Donaldson Coal Pty Limited

Abel Underground Mine

Part 3A Environmental Assessment Response to Submissions

Application No. 05_0136

Figure 3 Ventilation fan – graphical representations

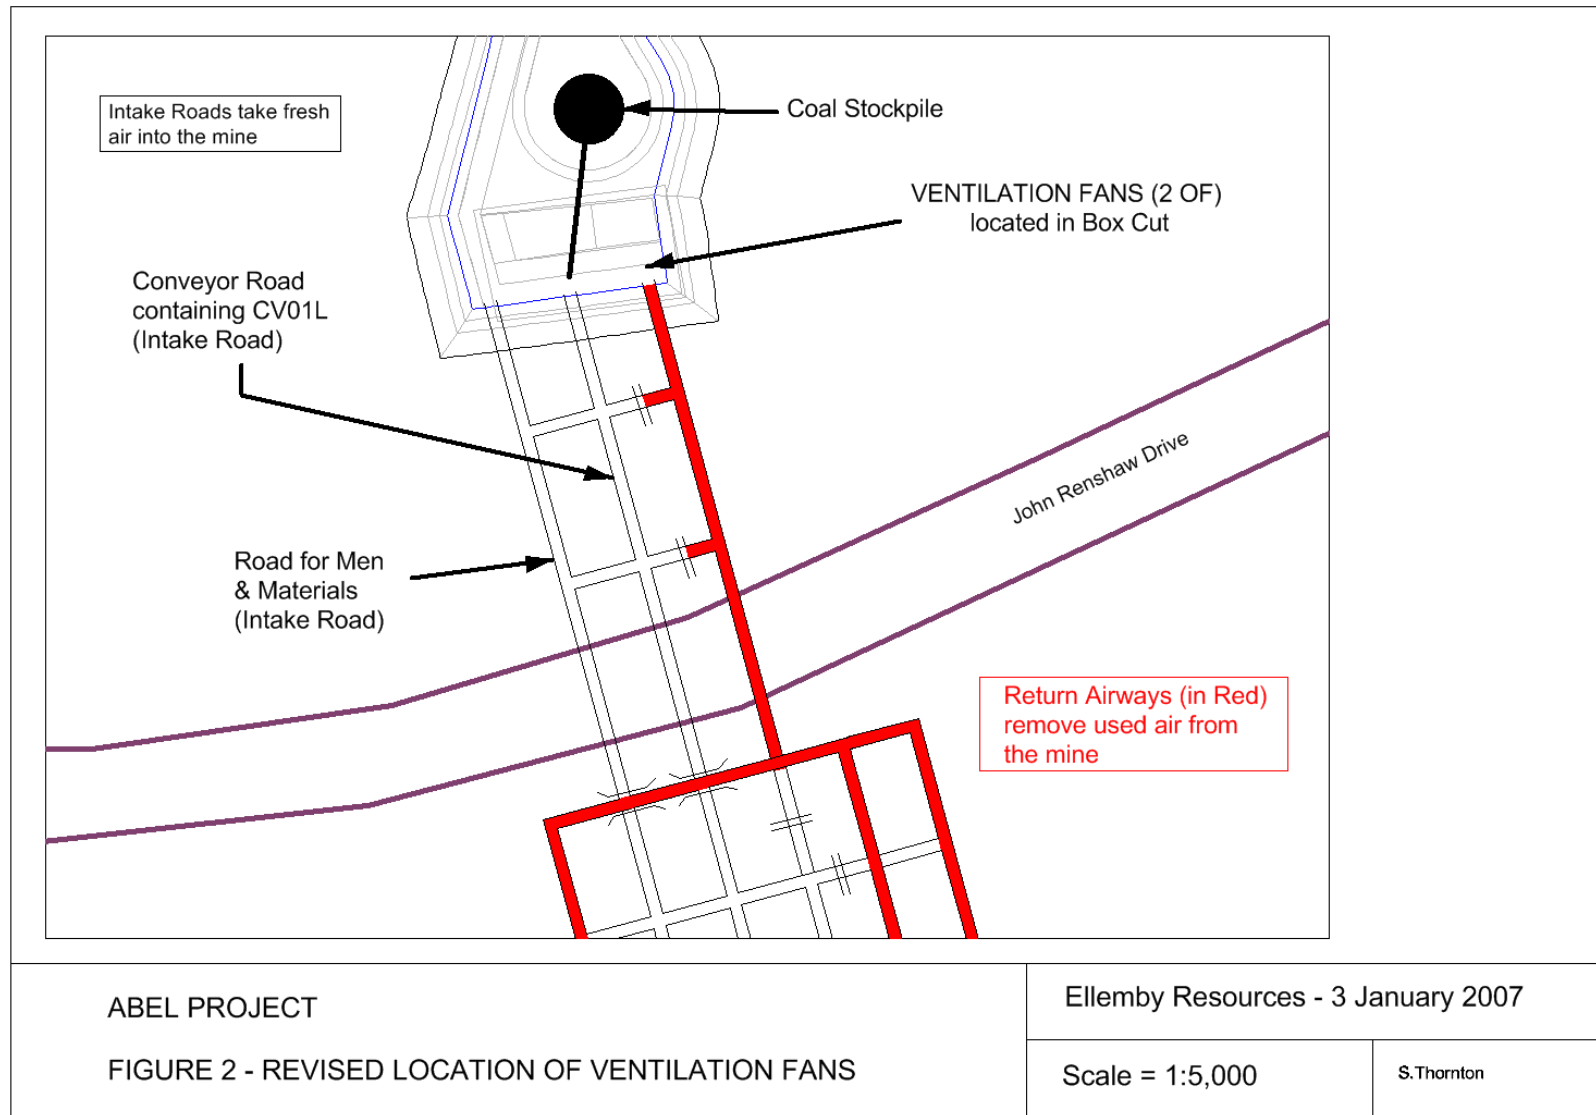
Some concern was raised by the submissions regarding the size and scale of the ventilation shaft and fan to be located south of John Renshaw Drive. The Visual Impact Assessment provided as Appendix M, Volume 5 of the Environmental Assessment noted that the lower topography of the immediate area and intervening vegetation would provide a 'visual screen' for the ventilation infrastructure from surrounding areas. One submission (L28) was concerned that the ventilation site was on their land. The proposed site is on land owned by Donaldson Coal.

Due to the concerns raised regarding the ventilation shaft and fan, it is now proposed to locate the required infrastructure on the northern side of John Renshaw Drive, near the underground portal that provides access to the Abel mine. This revised location is shown on Figure 2. The ventilation fan would be placed at the eastern portal. Figure 3 shows a graphical representation of a similar ventilation system, showing what the Abel ventilation system would look like within the portal. As can be seen by Figure 3, the system would be located within the void and hidden from external viewpoints by the high void walls.

The ventilation fan infrastructure in this revised location would generally be screened from locations outside the site as it would be within the void created by the completion of Donaldson Open Cut Coal Mine. Any part of the fan that could be viewed from more distant viewpoints, for example, Black Hill, would be seen in this location as a part of the general mine infrastructure.

The project noise and air quality consultants have considered any change in impact from the relocation of the ventilation fan to the portal area. The Noise consultants note that *'the revised ventilation fan location has advantages in terms of noise emission as additional noise attenuation is*

provided by the mine pit surrounding the portal. The additional topographic screening will result in a reduction on noise levels at receivers surrounding the site. The relocation...will result in a decrease of noise from the ventilation fan at noise sensitive receivers surrounding the Abel Coal Mine site.'

The air quality consultants consider that *'relocating the ventilation system to the portal would not be expected to have any adverse air quality impacts.'* Appendix C provides details of this response.
